Planning and Land Use Committee Report For the Meeting of October 1, 2015

Development Permit with Variances Application No. 000404 for 701 Tyee

Road (Railyards)

A3.10

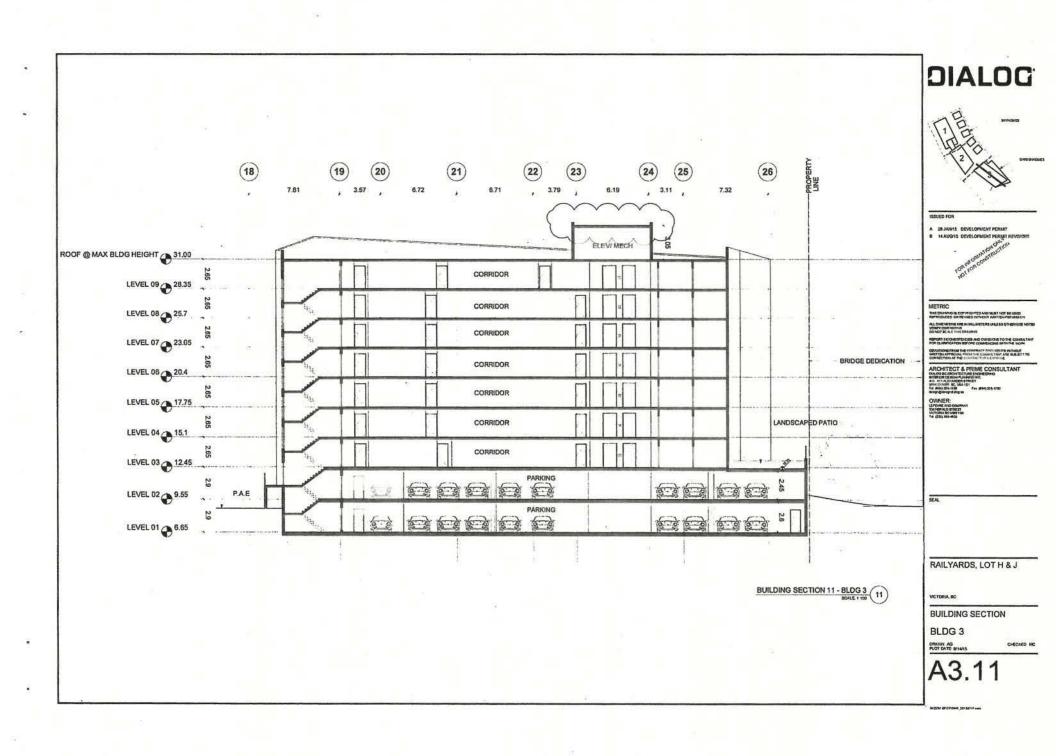
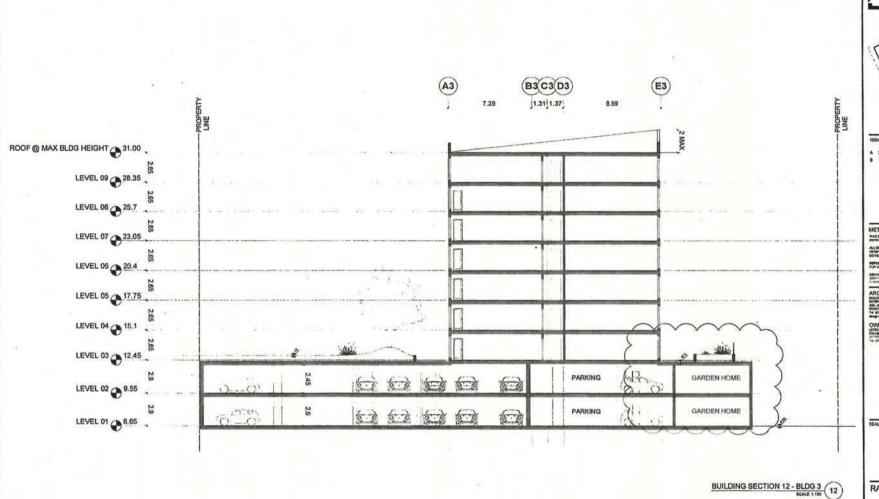
See the Architectural drawing, A3.11. The Building 3 rooftop finishes at geodetic height, 31.00m, the maximum allowable height. The only elements built above are the elevator mechanical room and parapet walls for roofscape articulation. All the habitable space will be under the maximum allowable height. To create a meaningful gateway feature at the base of the bridge head, we strongly believe that these roof articulations are necessary from the urban design perspective and worth supporting.
